## TAFT KNOLLS III JSP16-67

Public Hearing at the request of 25150 Taft Road, LLC for Preliminary Site Plan With Open Space Preservation Option, Site Condominium, Wetland Permit, Woodland Permit and Stormwater Management Plan Approval. The Subject Property is located in Section 22, South of Eleven Mile Road and East of Taft Road and is Zoned R-4 (One Family Residential). The applicant is proposing to construct up to 15 unit single-family residential development (Site Condominium) utilizing the Open Space Preservation Option.

# PLAN REVIEW CENTER REPORT

**Review Date:** May 05, 2017  
**Review Type:** Preliminary Site Plan  
**Project Name:** JSP16-67 Taft Knolls III  
**Plan Date:** March 30, 2017  
**Prepared by:** Sri Komaragiri, Planner  
**Contact:** **E-mail:** skomaragiri@cityofnovi.org; **Phone:** (248) 735-5607

DRAWN: MCS  
DESIGNED: MCS  
APPROVED: MGC  
P.E. JOB NO.: 16-472  
SCALE: AS SHOWN  
**S1**  
SITE PLAN

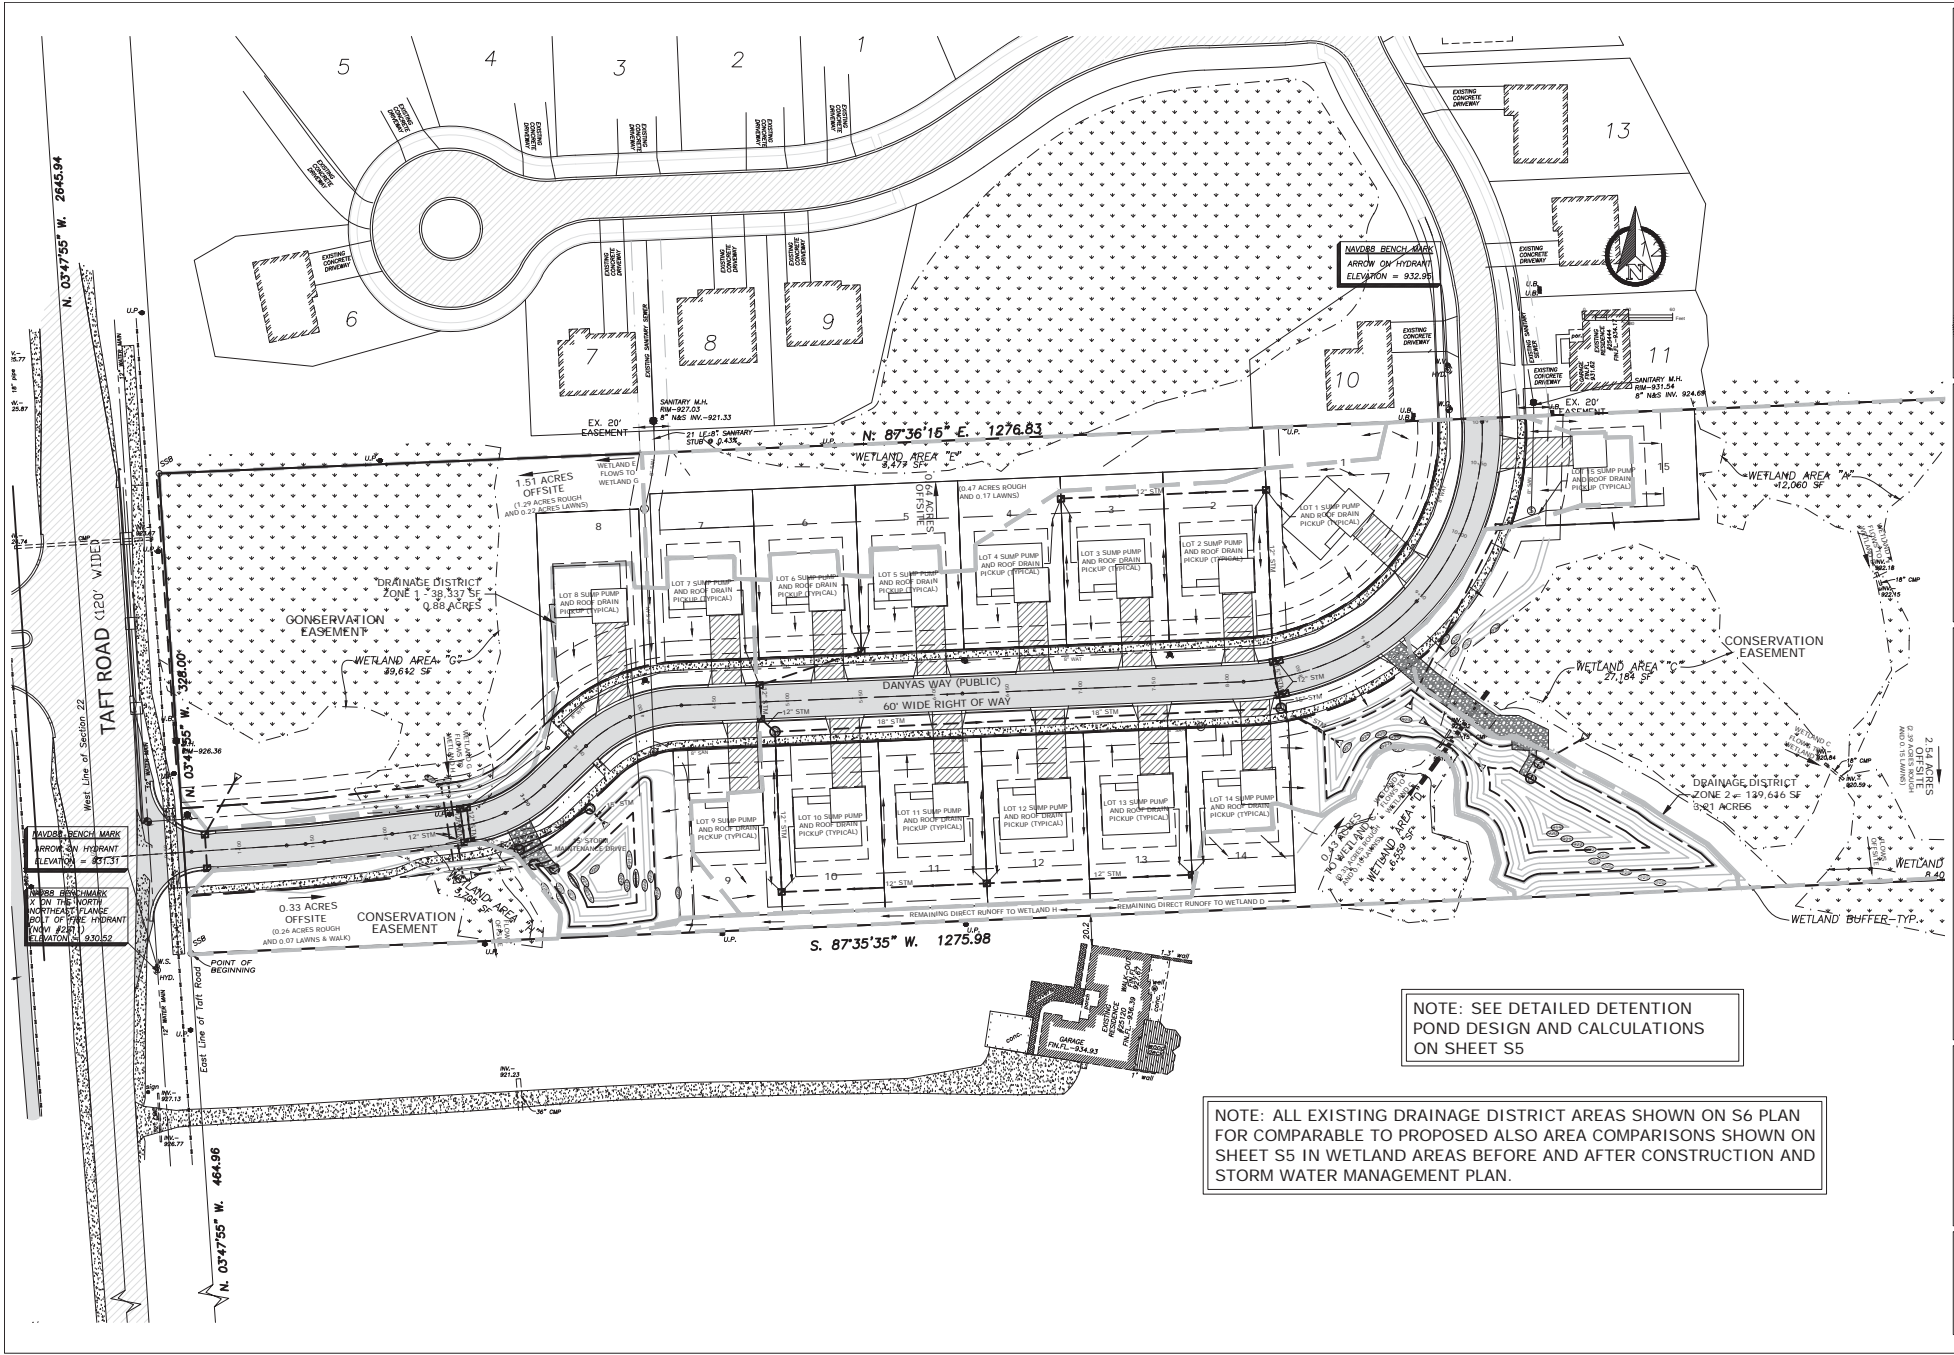
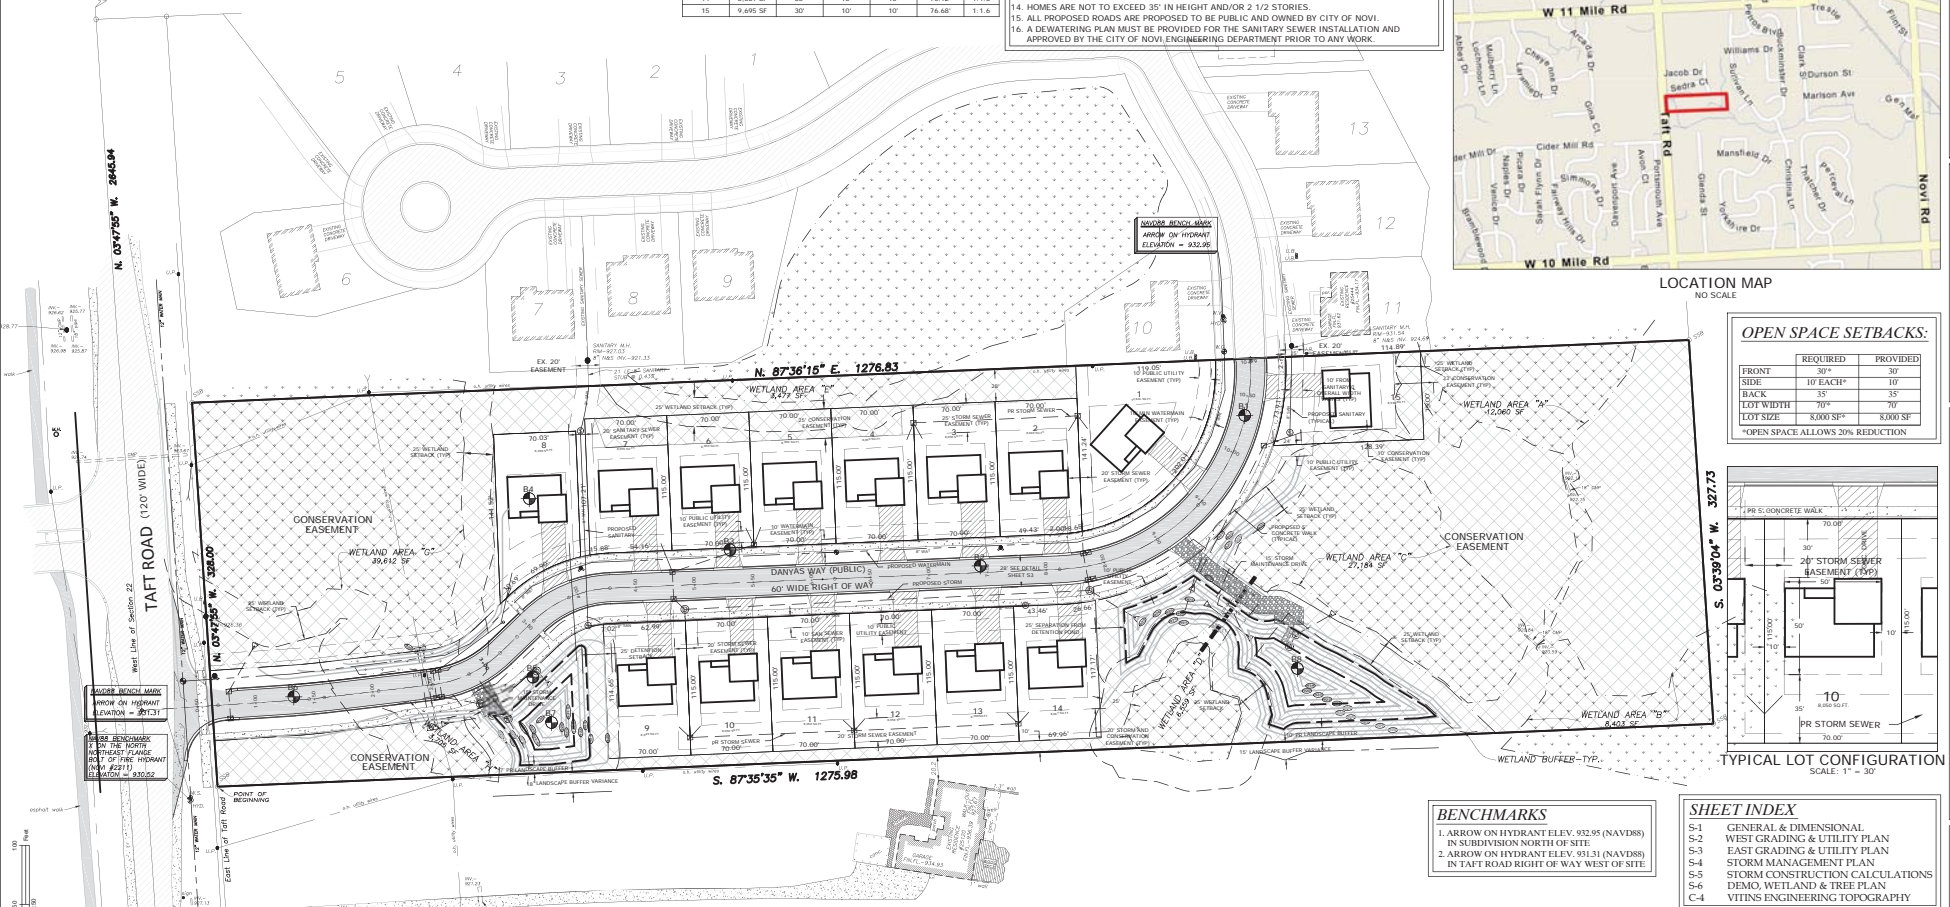
3. Non-Access Greenbelt: A 40 ft. non-access greenbelt is required adjacent to Taft Road. **It does not appear there would be any conflicts with the current layout. Please show and label the non-access greenbelt on the plans.**

3. Sheet S1: The proposed 10 ft. wide water main easement is indicated to be approximately 6 feet onto the proposed public right-of-way. Easement is not necessary if the utility, private or public, is located within the public right-of-way. Also, it does not appear that the shown easement is necessary provided that the water main maintains adequate distance from the right-of-way line. Provide dimension for the water main distance from said line.
4. Provide three (3) signed and sealed sets of revised utility plans along with the MDEQ permit application (1/07 rev.) for water main construction. The Streamlined Water Main Permit Checklist should be submitted to the Engineering Division for review, assuming no further design changes are anticipated. Utility plan sets shall include only the cover sheet, any applicable utility sheets and the standard detail sheets.

**BONDAFIDE PLAN**

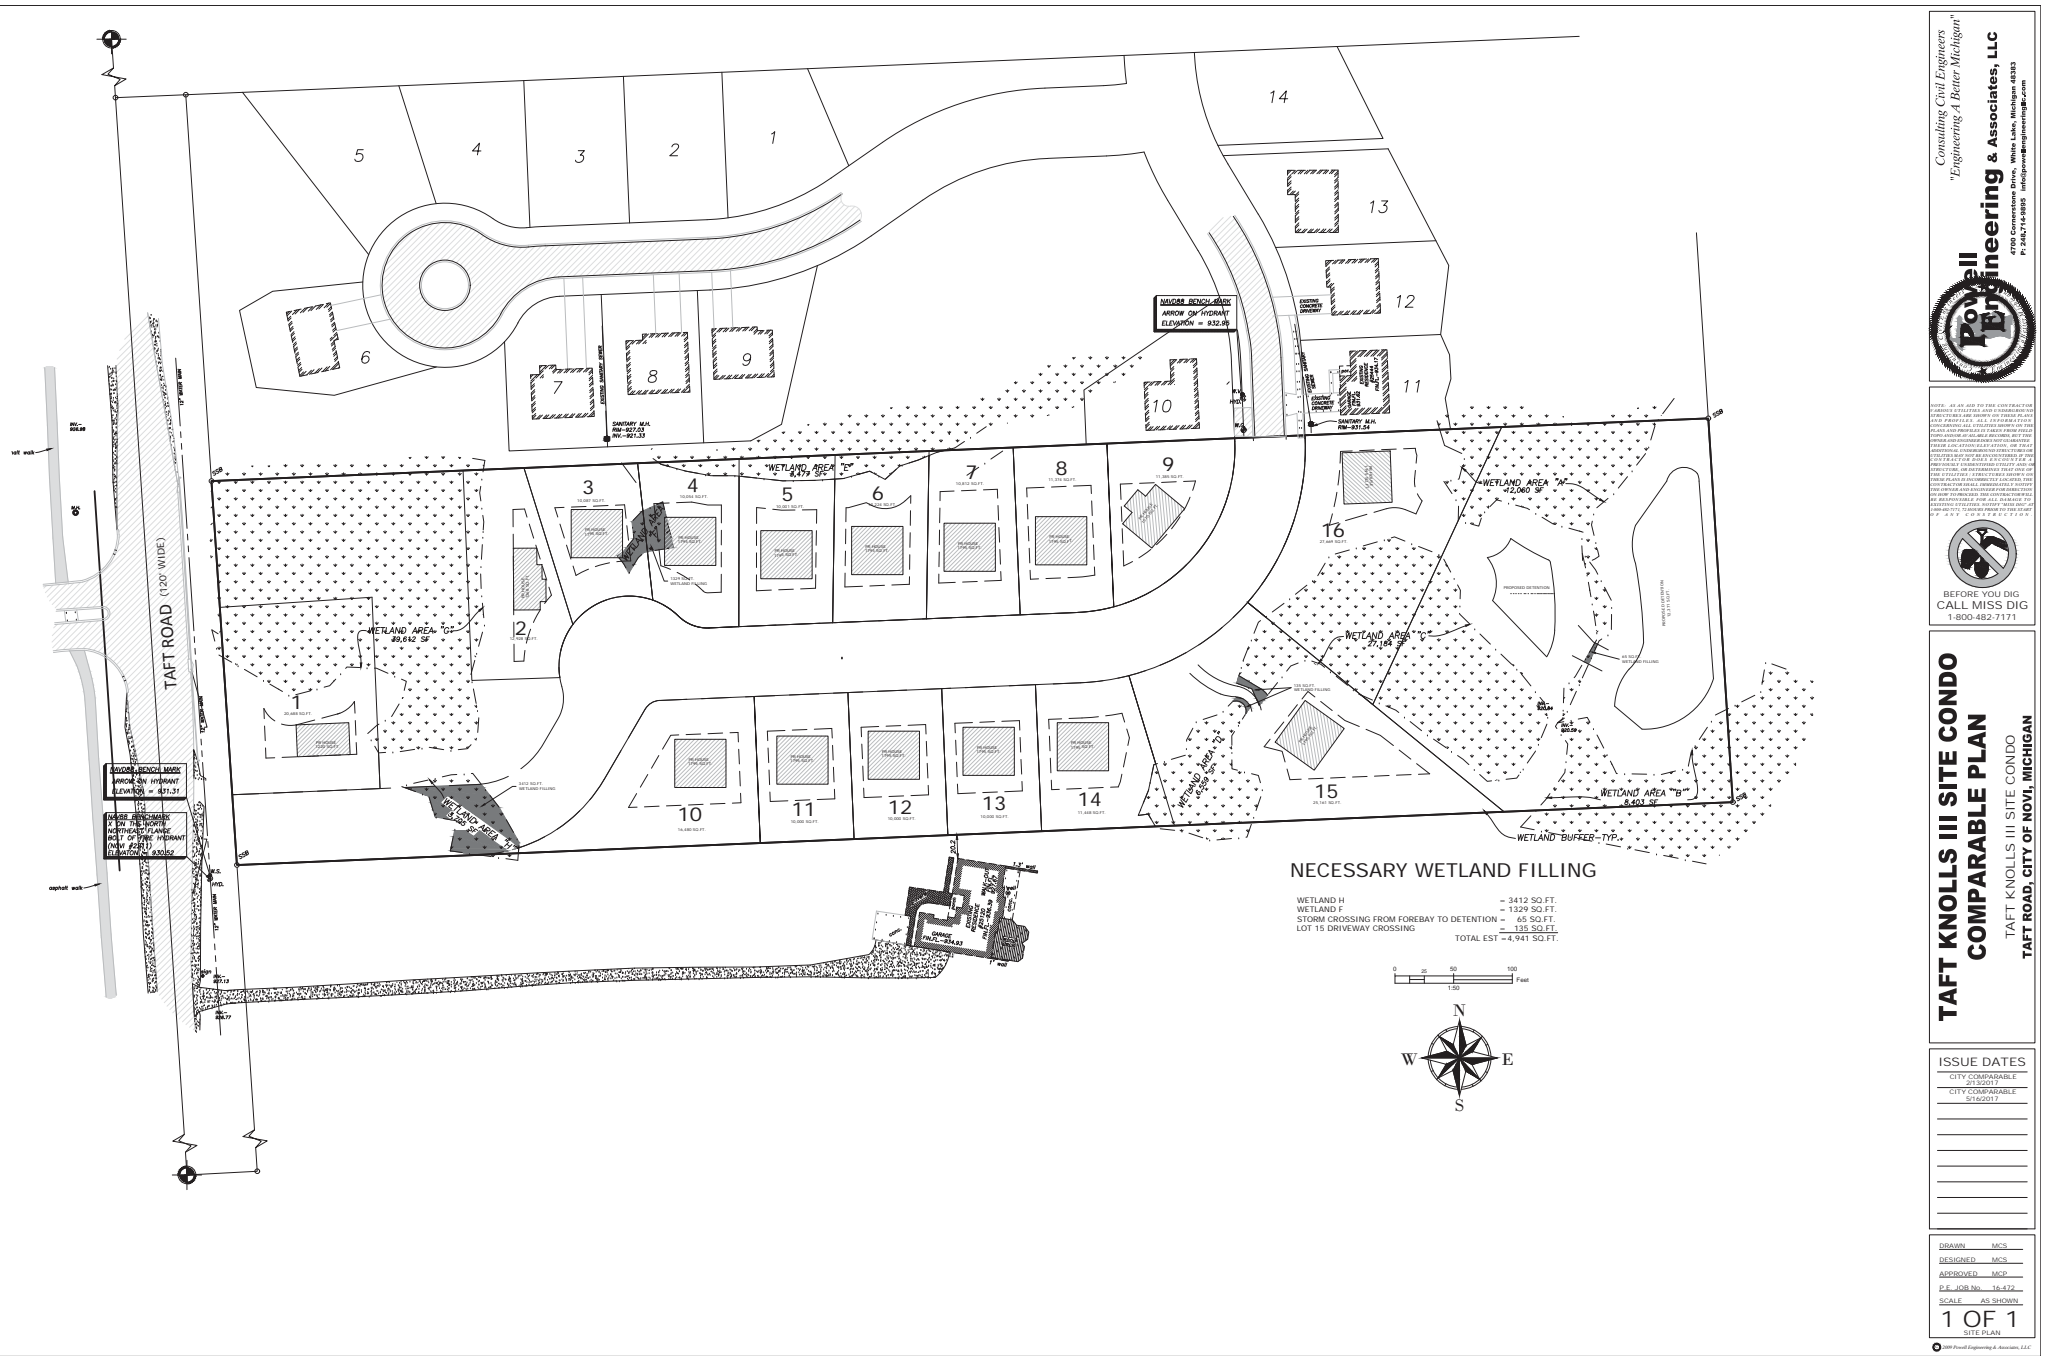
2. Bonafide plan: A parallel plan is required, which identifies how the property will be developed under conventional developmental standards. A bonafide plan is included in the plan which indicates 16 lots that can be developed under conventional development standards. The plan included additional details such as setbacks, frontage, conceptual storm water management and wetland fills. **Staff reviewed the plan and has determined the proposed density is allowable based on the maximum density proposed on the Bonafide plan. The Open Space Preservation plan proposes 15 lots, while the Bonafide plan indicates 16 lots.**

Figure 1. City of Novi Regulated Wetland & Woodland Map (approximate project boundary shown in red). Regulated Woodland areas are shown in green and regulated Wetland areas are shown in blue).

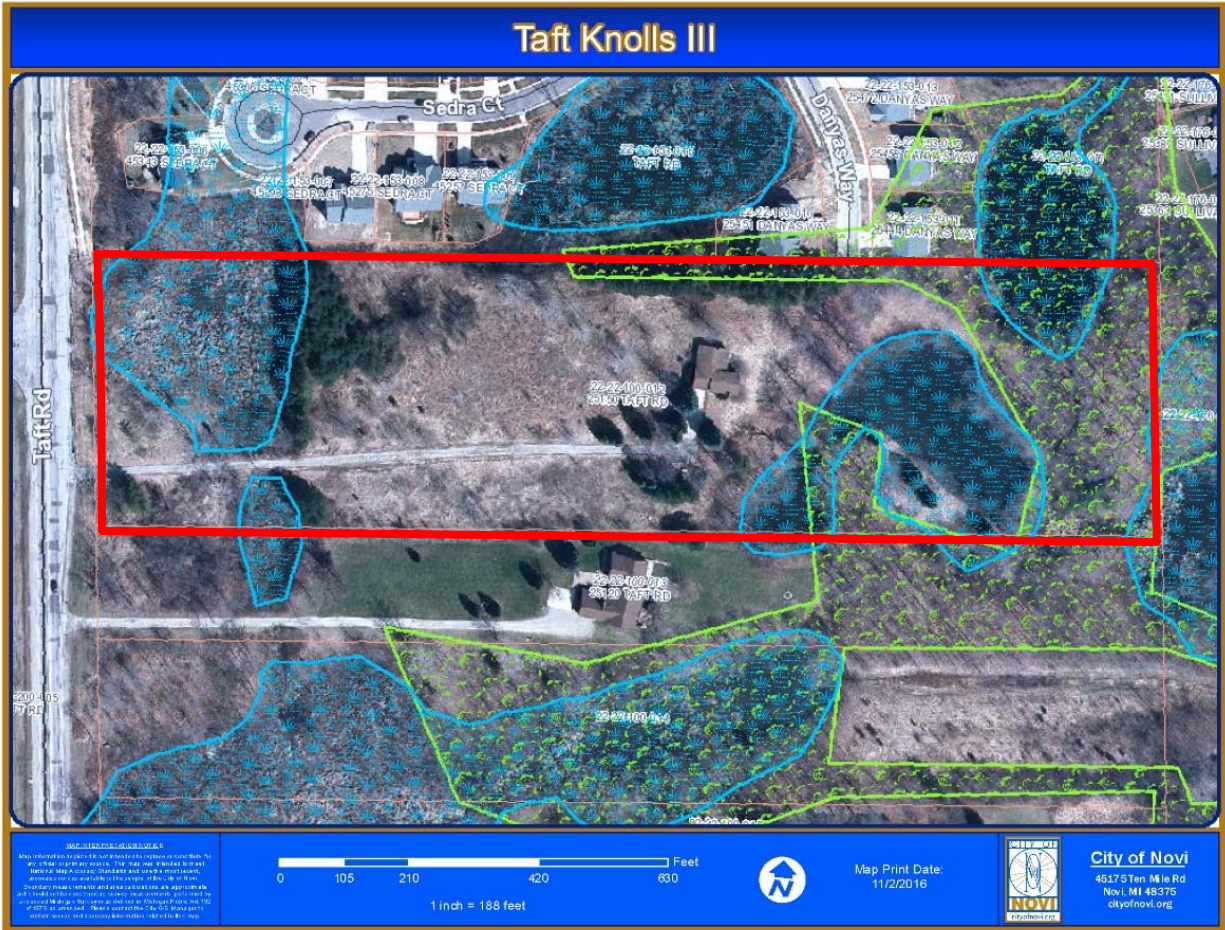
ECT's in-office review of available materials included the City of Novi Regulated Wetland and Watercourse map, USGS topographic quadrangle map, NRCS soils map, USFWS National Wetland Inventory map, and historical aerial photographs. The site includes areas indicated as City-regulated wetland on the official City of Novi Regulated Wetland and Watercourse Map (see Figure 1).

Figure 1. City of Novi Regulated Wetland & Woodland Map (approximate project boundary shown in red). Regulated Woodland areas are shown in green and regulated Wetland areas are shown in blue).

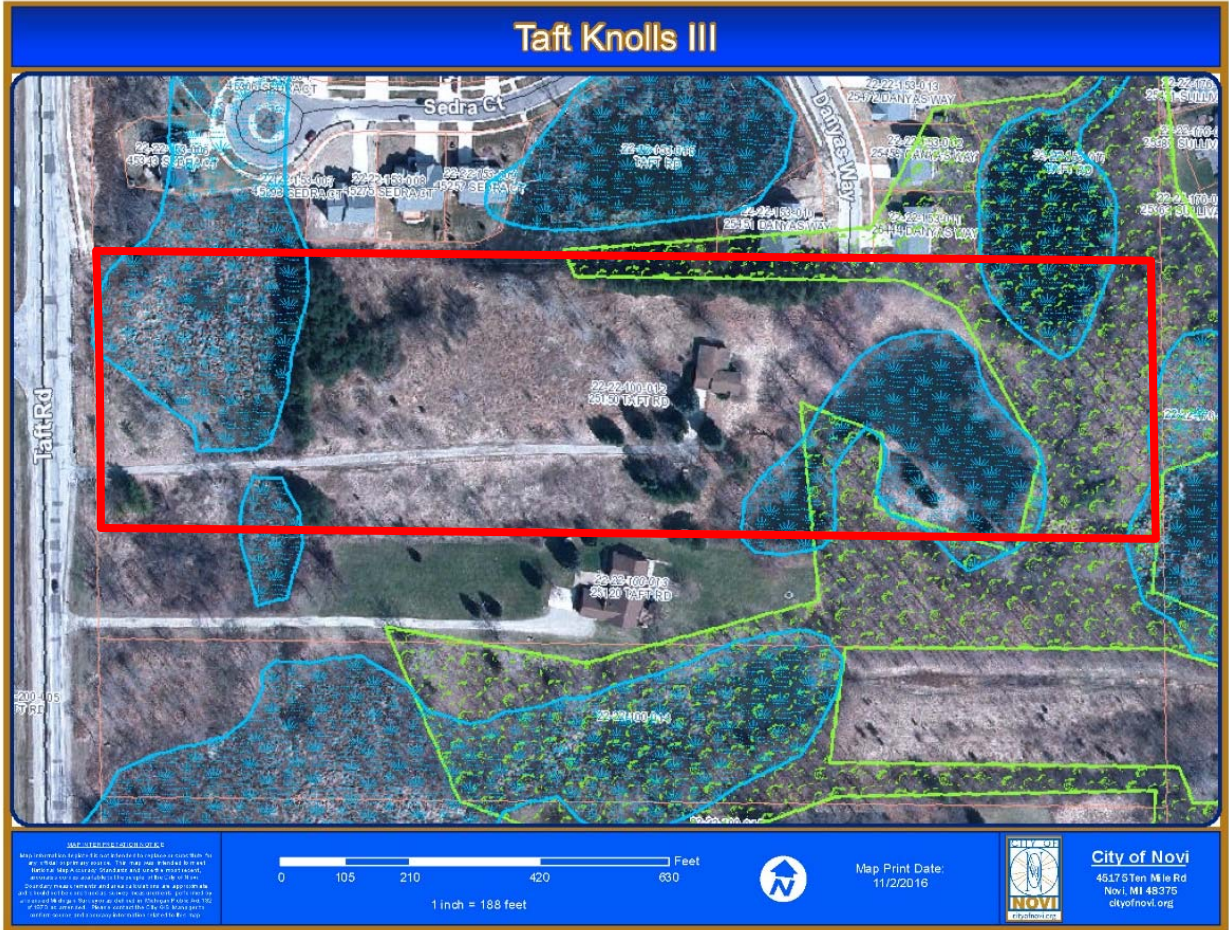
ECT has reviewed the City of Novi Official Woodlands Map and completed an onsite Woodland Evaluation on May 2, 2017. ECT's in-office review of available materials included the City of Novi Regulated Woodland map and other available mapping. The subject property does include areas indicated as City-regulated woodland on the official City of Novi Regulated Wetland and Watercourse Map (see Figure 1).
